NATOMAS CORPORATE CENTER

CITY PLANNING COMMISSION

MEETING DATE June 14, 1984

CPC ITEM NO. 21

PLANT LEGEND & SUN SHADE DIAGRAM

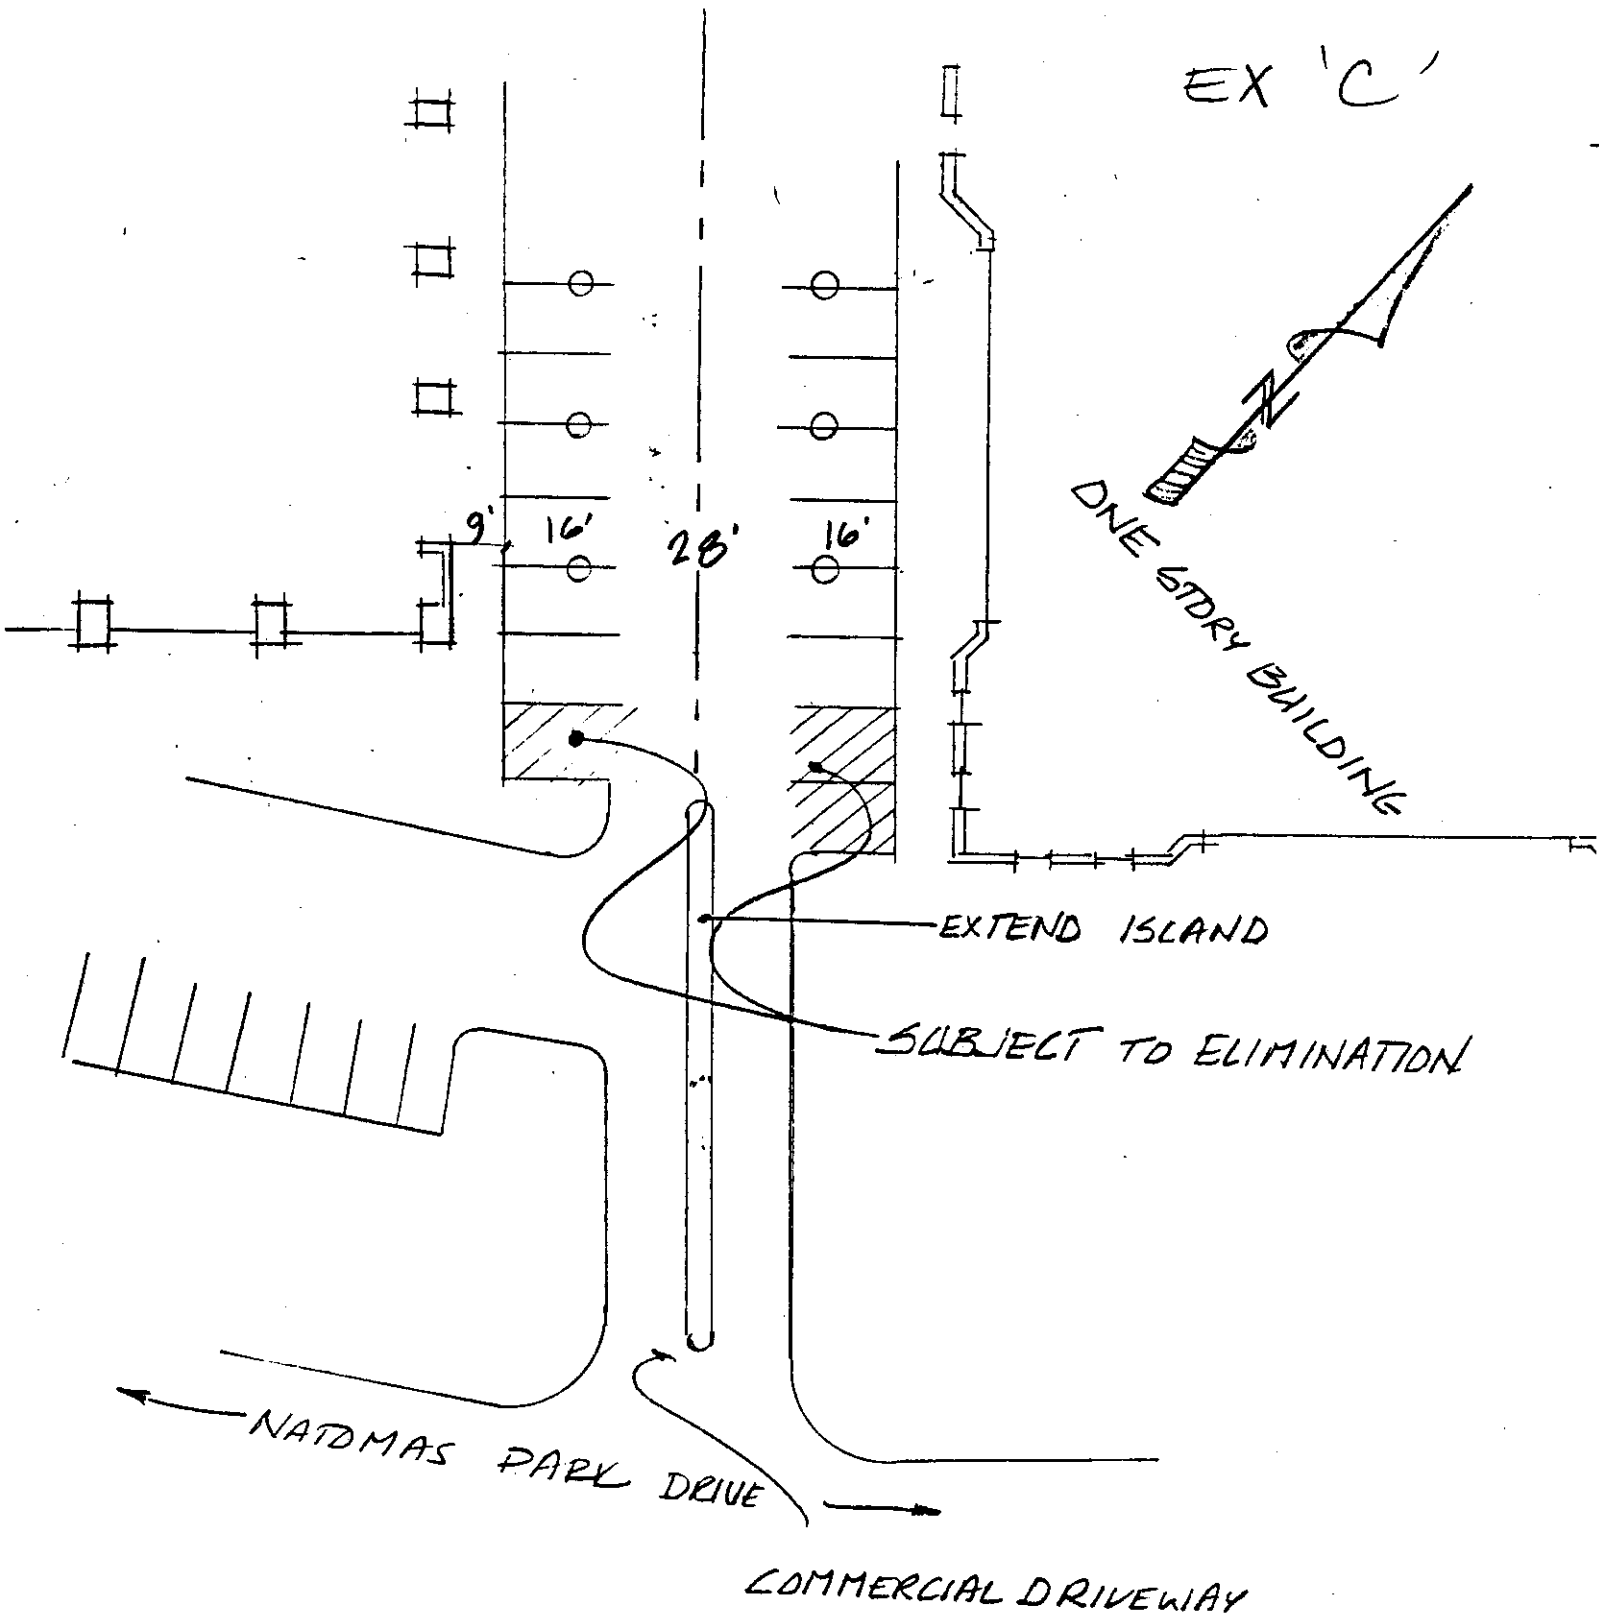
2. The on site landscaping exceeds the requirements set forth in the development guidelines and the landscape setbacks comply with the minimum 40 foot setback along West El Camino and 25 feet setback on Natomas Park Drive. Staff does, however, recommend that a minimum of 5 foot landscaped undulating berms be provided along West El Camino and Natomas Park Drive to screen the on site parking area from adjacent residential uses.

3. The site plans indicate that the parking lot shading does not meet the requirement of 50-percent which is necessary to meet the standards set forth in the Natomas Corporate Center development guidelines. In addition to the shading deficiency, the site plan indicates that the tree wells located in the parking lot on the northwest side of the site are not adequate to accommodate shade trees. These tree wells must be increased to a minimum of 6 feet of planter area depending on the type of tree selected for these planters. A six inch raised planter curb will also be required around the tree wells.

- 2. The applicant shall provide a minimum of 50-percent shading in the parking area. All planters shall conform to the minimum width for the type of trees proposed. Revised landscape, shading and irrigation plans shall be submitted to planning staff for review and approval prior to issuance of a building permit.

- 3. The 40-foot landscape planter along West El Camino and the 25 foot landscape planter on Natomas Park Drive shall be provided with a minimum 5 foot landscaped undulating berm.

REVISED DRIVEWAY
ENTRANCE

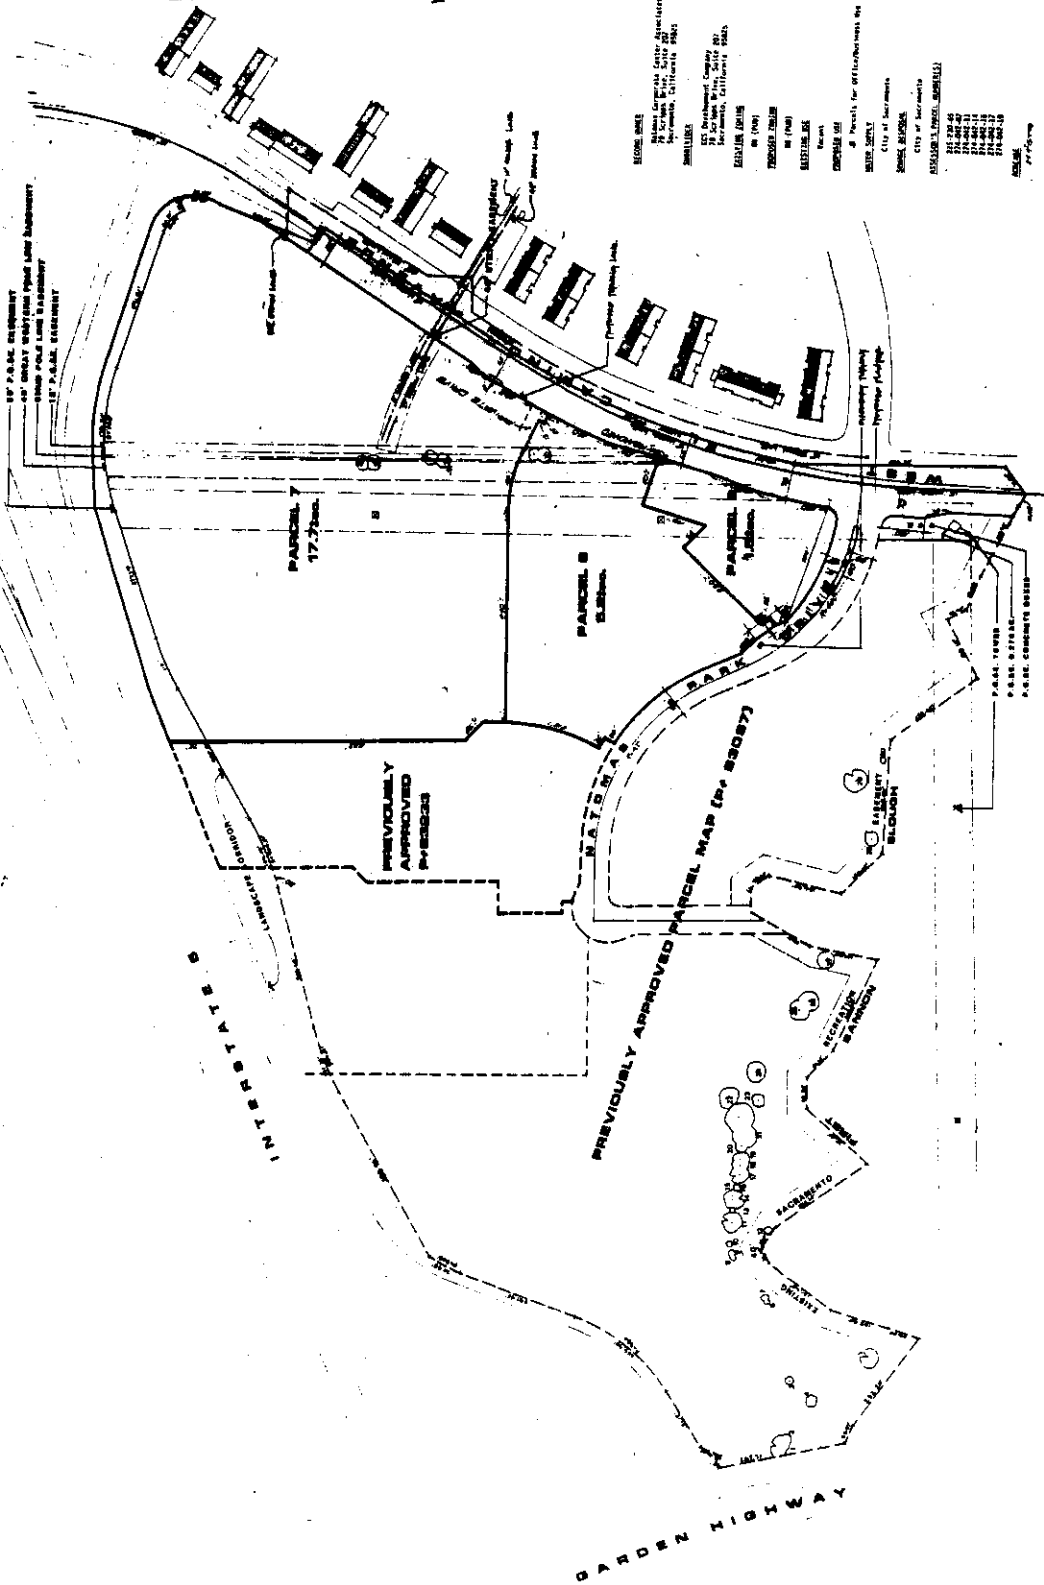
1. As proposed, this project is consistent with the development agreement for the Natomas Corporate Center which allows flexibility in the PUD Schematic Plan. The building elevations and materials are consistent with the design standards established in the development guidelines for the PUD. There is concern regarding site design with respect to the vehicular access from Natomas Park Drive. The City Traffic Engineer has indicated that traffic problems will occur unless this access point is eliminated or modified. The Traffic Engineer also indicated that driveway modifications will be necessary within the site to eliminate conflict with parking aisles. At the present time on-site parking is deficient by 3 spaces. It is expected that 5 additional parking spaces will be lost with the necessary driveway modifications. The applicant will be required to revise the plans by increasing the on site parking to the required minimum or to reduce the square footage of the buildings. The applicant has been working with the Traffic Engineer to resolve some of the problems. Proposed modifications are shown in Exhibit C.

- 1. The applicant shall redesign the site plan so that access and driveways do not create congestion to the satisfaction of the Traffic Engineer. Revised plans shall be submitted for review and approval of the Traffic Engineer prior to issuance of a building permit.
